Attachment I

**Effects of changing height of Cape's Dam on recreation, Texas wild
rice and fountain darter habitat in the San Marcos River, Texas**

**Watershed Systems Group, INC
San Marcos, Texas**

October 12, 2015

Figure 16. Computational mesh (upper left), location of physical measurements (upper right), cross section profile of the San Marcos River above Cape's Dam (lower left) and cross section profile of the Mill Race (lower right).

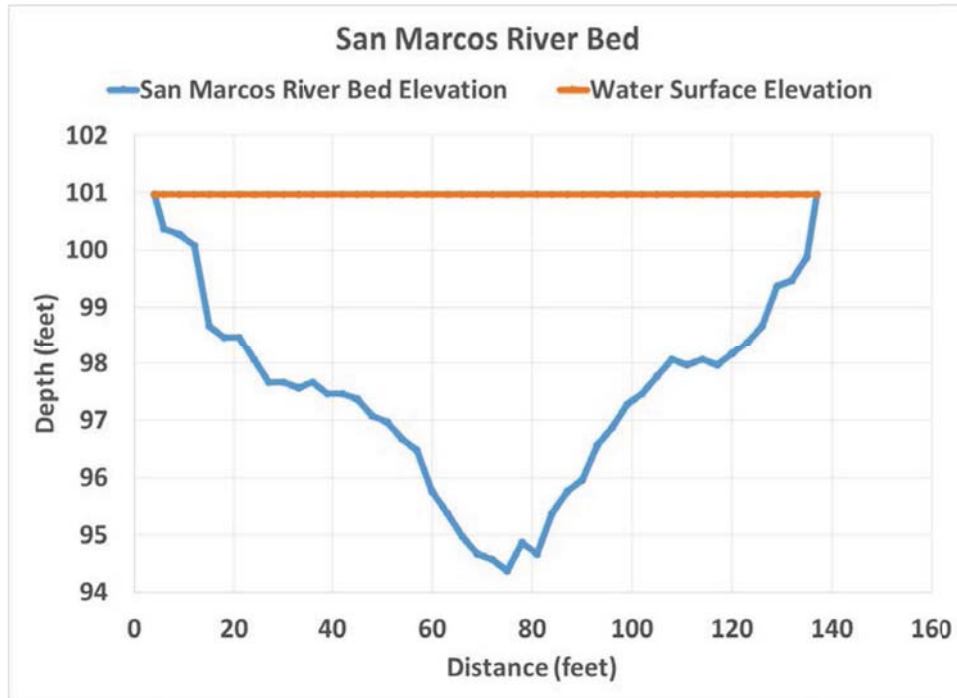
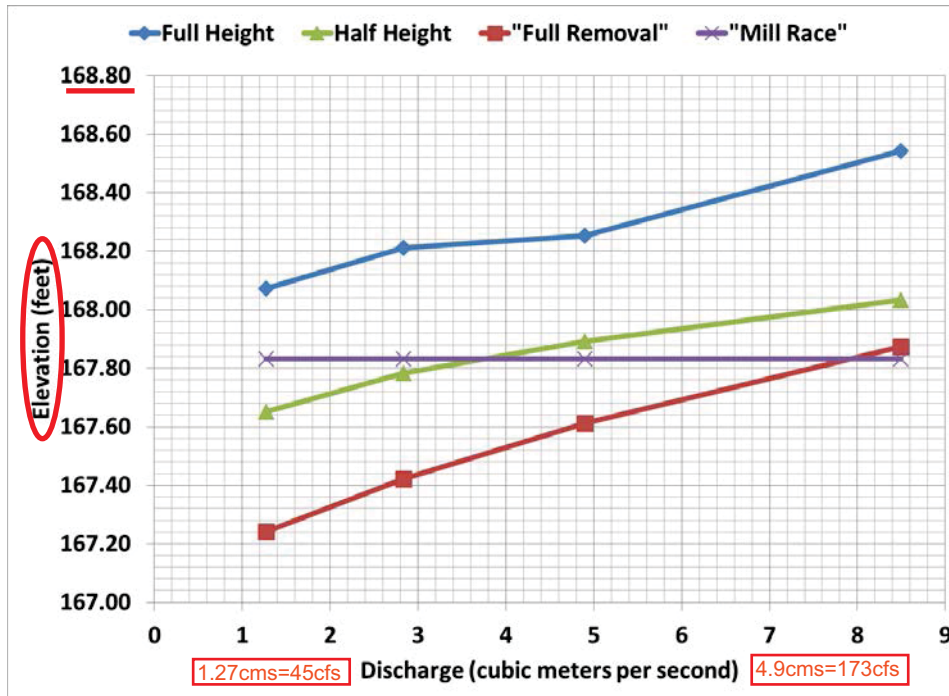
These horizontal scales are not the same, resulting in a visually-deceptive comparison as occurs in Figures 5 through 7

CORRECTED Figure 16 TO SHOW SAME HORIZONTAL SCALE on BOTH GRAPHS

This graph shows the unreliability of Hardy's published work. The Y-axis (vertical) is labeled "Elevation (feet)" but the values given are elevation in meters.

168.80m = 553.80ft
 168.00m = 551.18ft
 167.00m = 548.90ft

Figure 18. Percent of total surface area and percent change in Texas wild rice habitat compared to full height conditions.

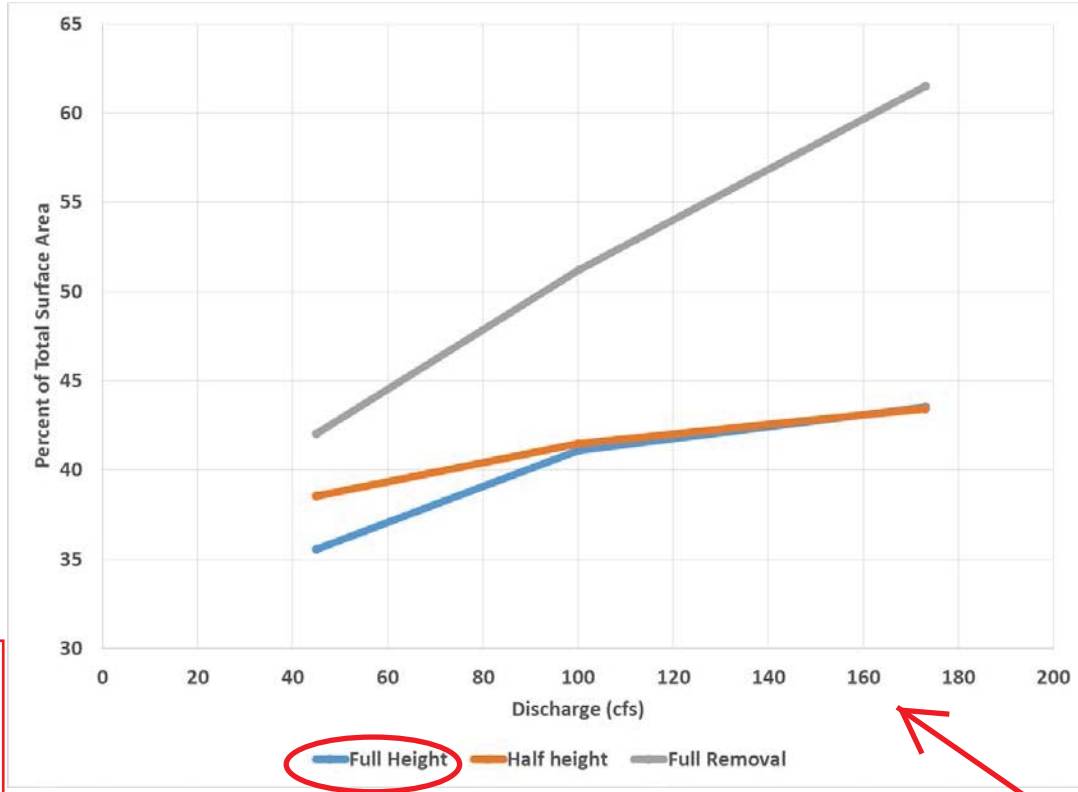
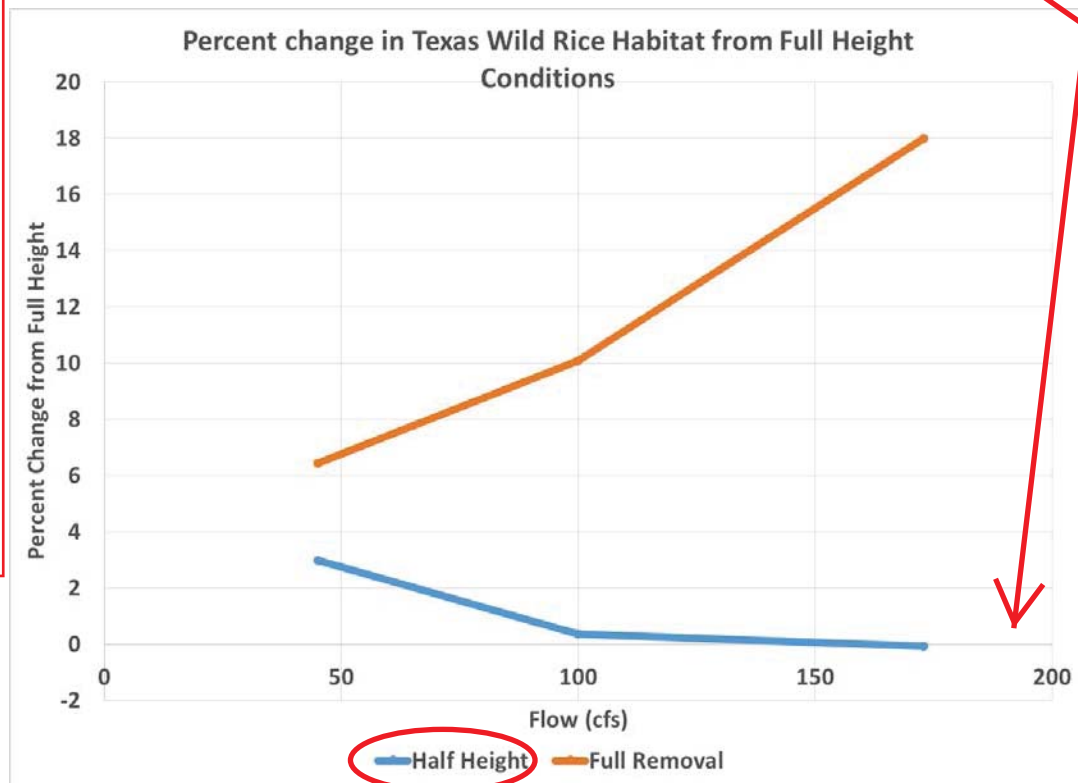
Hardy uses blue color in the top half of Fig 18 to represent "Full Height" but then uses the same blue color to represent "Half Height" in the bottom of Fig. 18.

The bottom of Fig. 18 purports to show the % change from Full Height conditions, but no line for Full Height exists in the bottom graph of Fig 18.

Figure 18 is confusing, at best.

In Att. H, Page 15, Hardy's June 2015 paper, concludes a small decrease of less than 0.5% at Half Height and a small increase of 0.6% at Full Removal.

Figure 18 of this report (Oct 2015), based on the same dam measurements and water flows, reports there will be an 18% increase - but it is unclear as to whether that occurs at Half Height or Full Removal due to Figure 18's ambiguity.

Figure 19. PAR reduction with depth in Spring Lake compared to upstream of Cape's

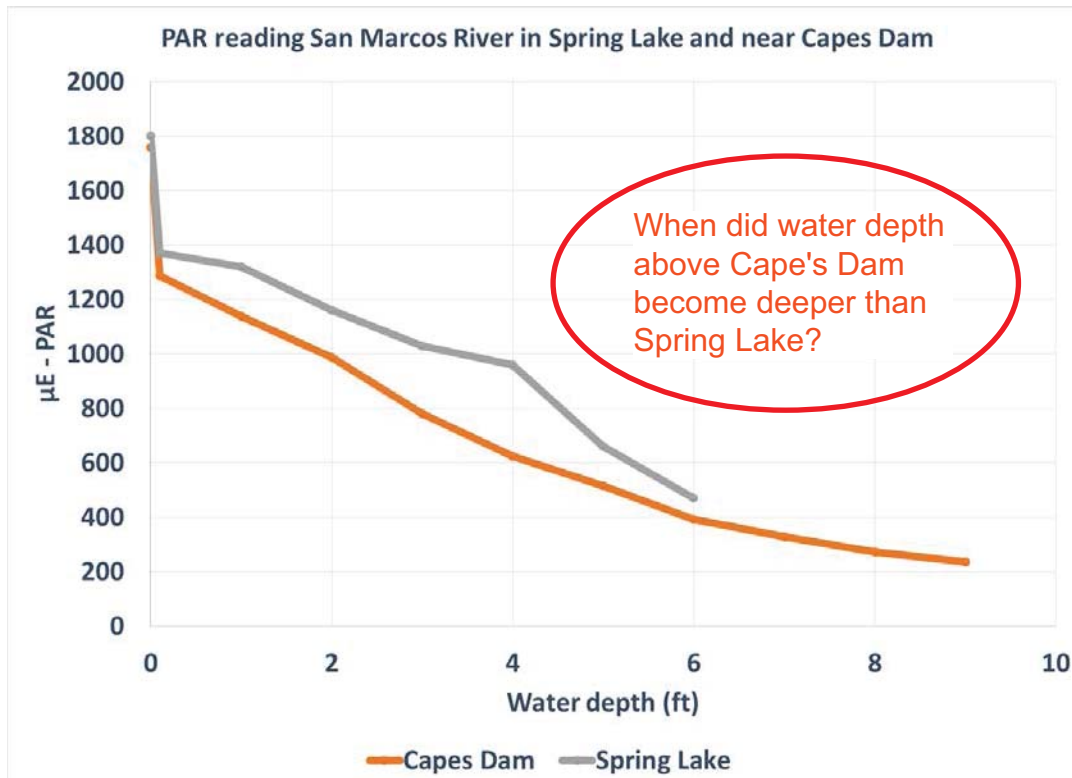
How does this graph comparing Spring Lake - a lake created by a DAM that is not being threatened with removal - with the area upstream from Capes Dam (i.e., the lake created by Capes Dam) show PAR reduction?

Additionally, Spring Lake is located at the source of presumably unpolluted water that is emanating from the underground springs which create the entire San Marcos River, and thus water in Spring Lake has much lower plant, suspended sediment and biological material present in it, which allows a greater level of photosynthesis at greater depths than exist in the lake created by Capes Dam.

Figure 20. Percent of total stream area suitable for fountain darters under full height, half height and full dam removal.

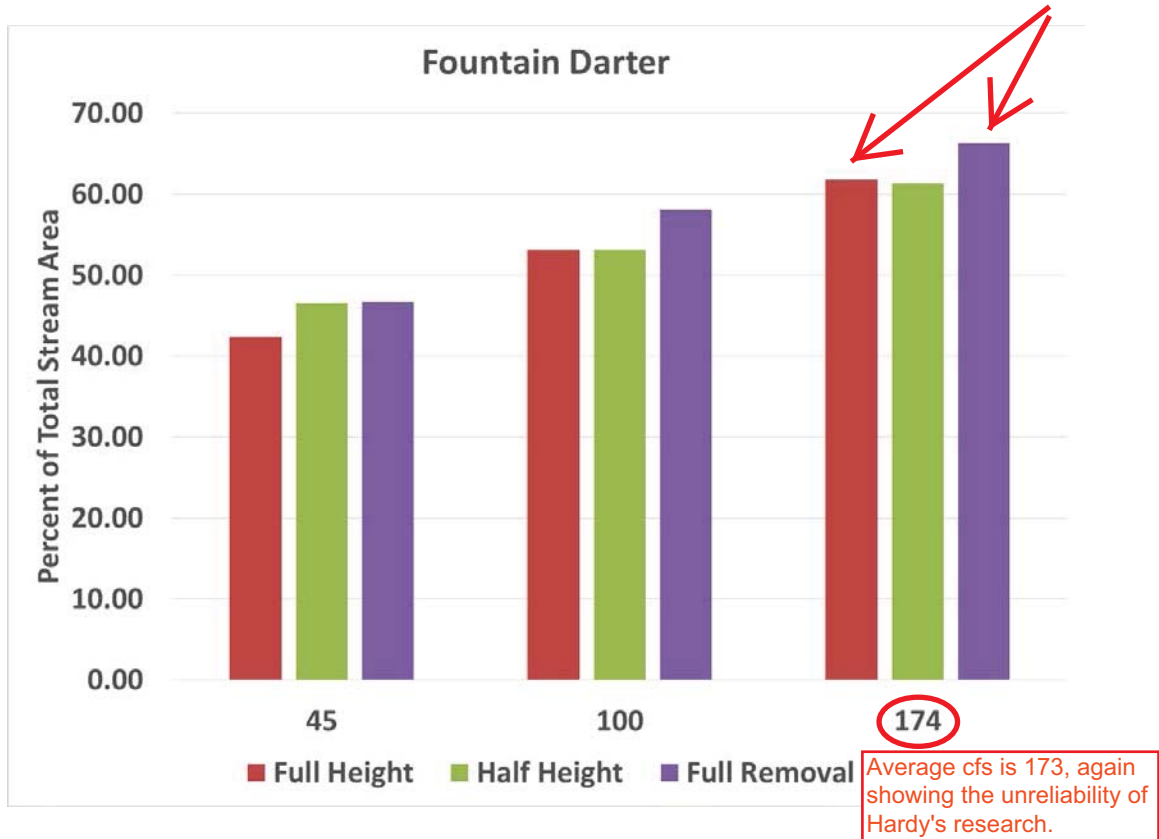
The modelling for Fountain Darter (FD) is introduced as including vegetation (see. P. 12), yet when the results are presented (p. 26-27) they are based only on depth and velocity. Modeling only including depth and velocity, while omitting vegetation, was used in the June 24, 2015 WSG report, which showed a 0.4% increase in suitable FD habitat. This report uses the same modelling and yet shows a 5% increase in suitable FB habitat - How does Dr Hardy answer for this significant discrepancy in results?

Figure 22. Fountain darter habitat quality under full height, half height and full dam removal at 100 cfs.

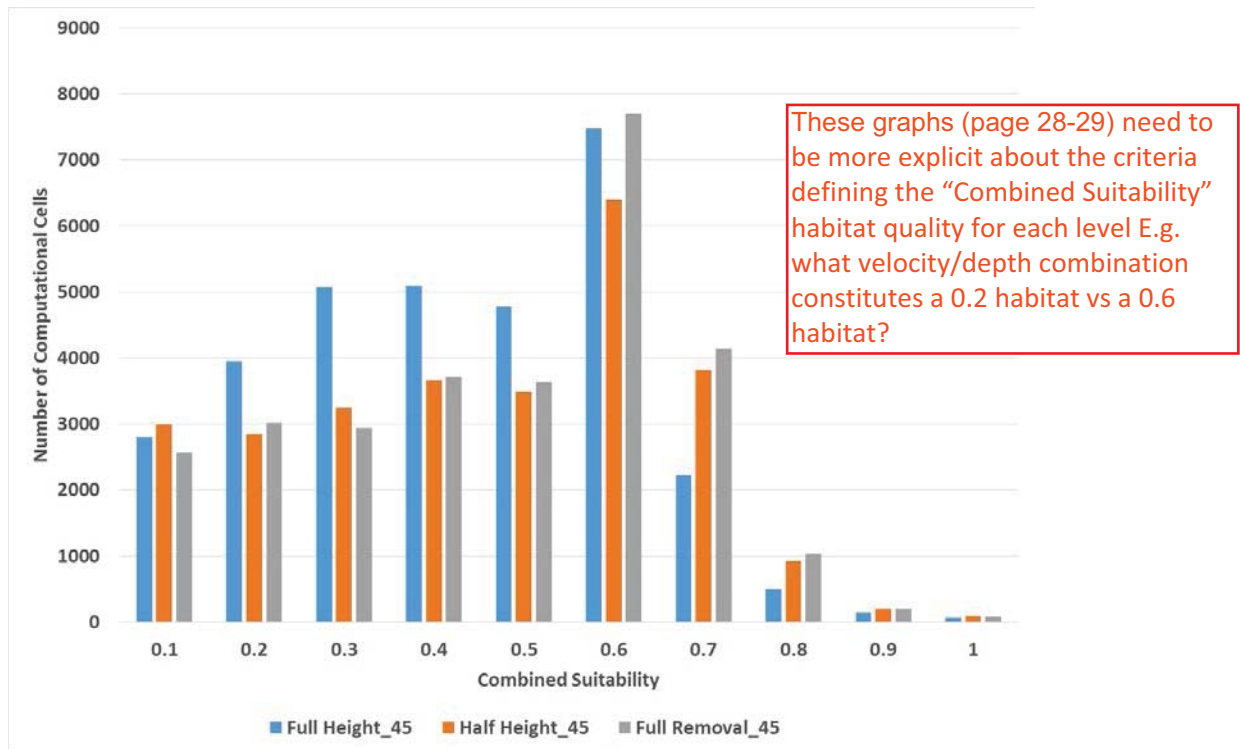
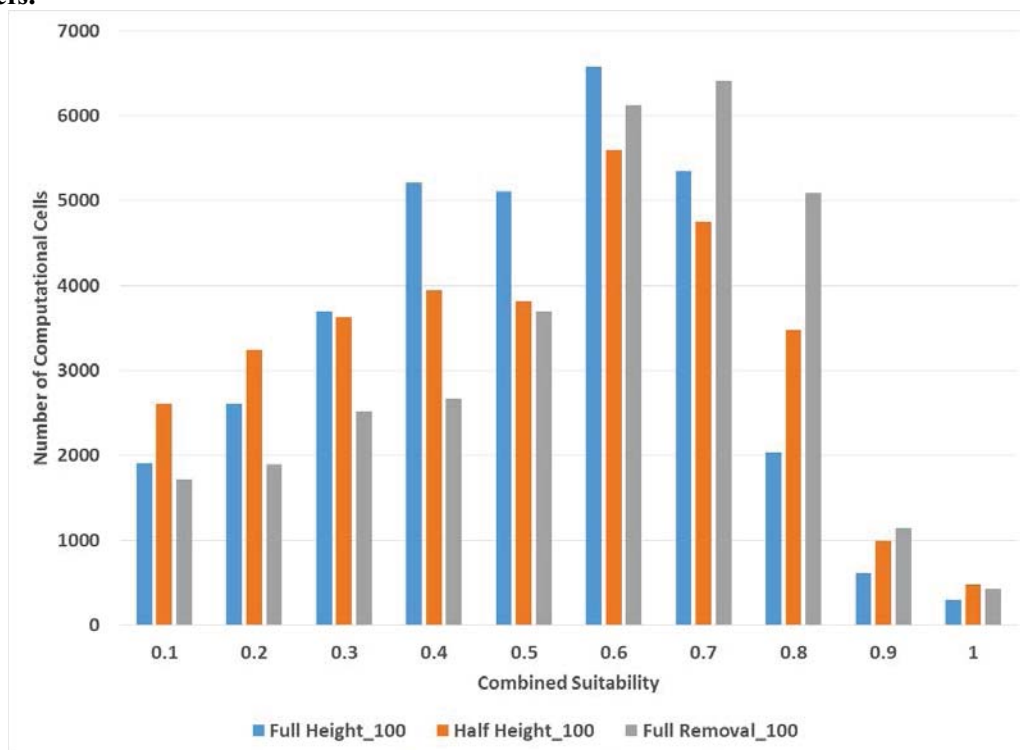
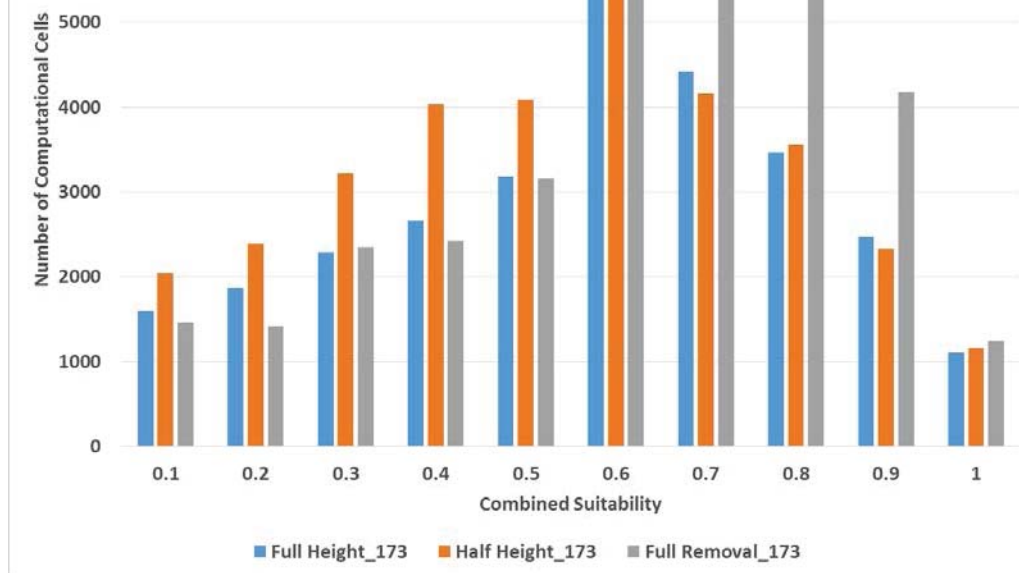
Furthermore this graph omits the "above-average flow rate" of 300 CFS, which Hardy uses on Page 10 & Table 3 of this report. In other words, Page 10 & Table 3 of this report are based on a nearly double CFS than Hardy's prediction of a **changed conclusion to 5%** increase in favorable habitat for the Fountain Darter.

These graphs (page 28-29) need to be more explicit about the criteria defining the “Combined Suitability” habitat quality for each level E.g. what velocity/depth combination constitutes a 0.2 habitat vs a 0.6 habitat?
